Consensus Results: Corrections Needed in Clause 180.9.6

Rev B

Addresses Comments: R2-15, R2-16, R2-17, R2-18, R2-126, R2-141, R2-144, R2-188, R2-189, R2-206

Figure 180–10—TDECQ reference equalizer functional model

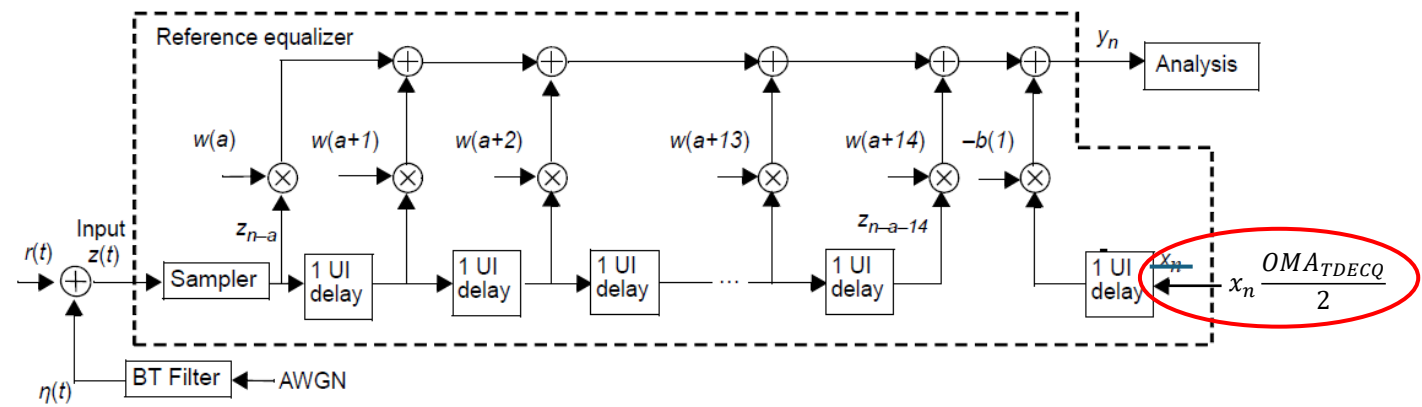
Comments: R2-15,
R2-144, R2-188

➡ Footnote b on Table 180-16 is now consistent with Figure 180-10

Feed-forward tap DC gain ^a	—	1	
Number of feedback taps	N_b	1	
Feedback tap coefficient limit ^b	$b(1)$	0	0.33

^a The sum of all 15 feed-forward tap coefficients, $w(i)$.
^b The feedback tap coefficient $b(1)$ is referenced to $OMA_{TDECQ}/2$ (see 180.9.6.4 for definition of OMA_{TDECQ}).

Figure 180–11—Illustration of the TDECQ measurement

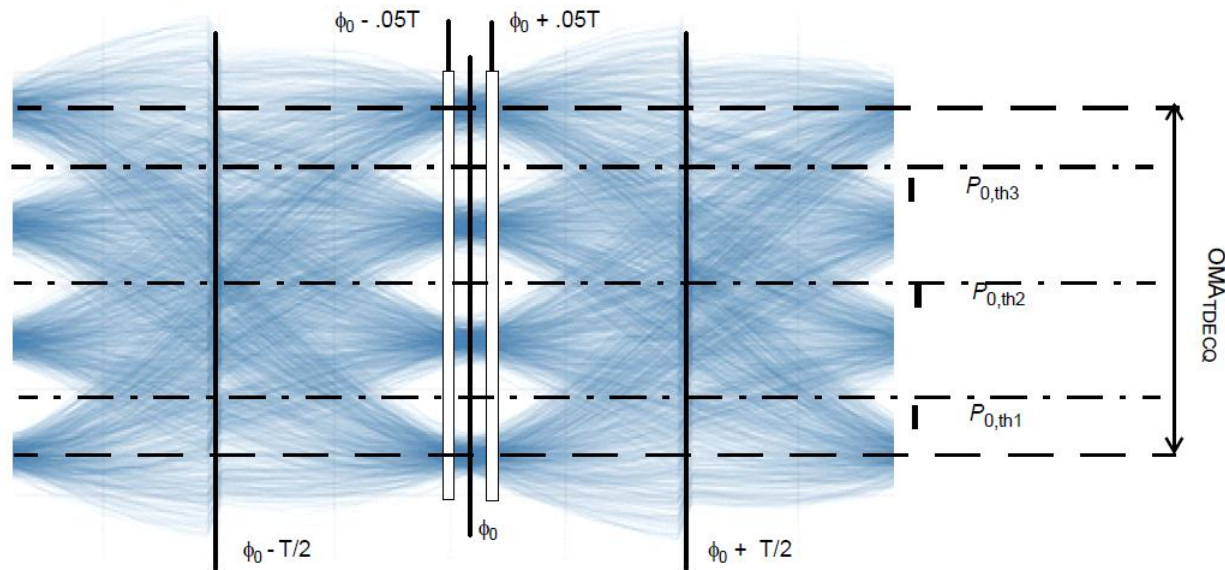
In D3.2, we do not mention at all how the values of y_n are determined away from $\phi = \phi_0$. We need those values for two reasons:

- We need the values in the regions defined at $\phi = \phi_0 \pm .05T$ to estimate symbol error rate, and
- The method defined in 180.9.5 to measure OMA_{TDECQ} is for a continuous-time (or over-sampled) signal with runs of threes and runs of zeros.

We can introduce the notion easily by talking about it when we introduce the eye diagram without being prescriptive.

An eye diagram to help illustrate TDECQ is shown in Figure 180–11. The eye diagram corresponds to the optimized equalizer setting at sampling phase ϕ_0 . The feedback symbol x_n changes at phase $\phi = \phi_0 - T/2$.

Insert here

The eye diagram can be constructed, for example, by using the equalizer taps optimized at ϕ_0 and varying the phase ϕ in Eq. 180-2 to generate an oversampled equalized waveform.

~~where OMA_{TDECQ} is measured on the equalized captured waveform y_n using the method defined in 180.9.5,~~
 where P_{ave} and OMA_{TDECQ} are measured on an oversampled equalized waveform, as illustrated in the eye diagram in Figure 180-11, using the method defined in 180.9.5 for OMA_{TDECQ} .
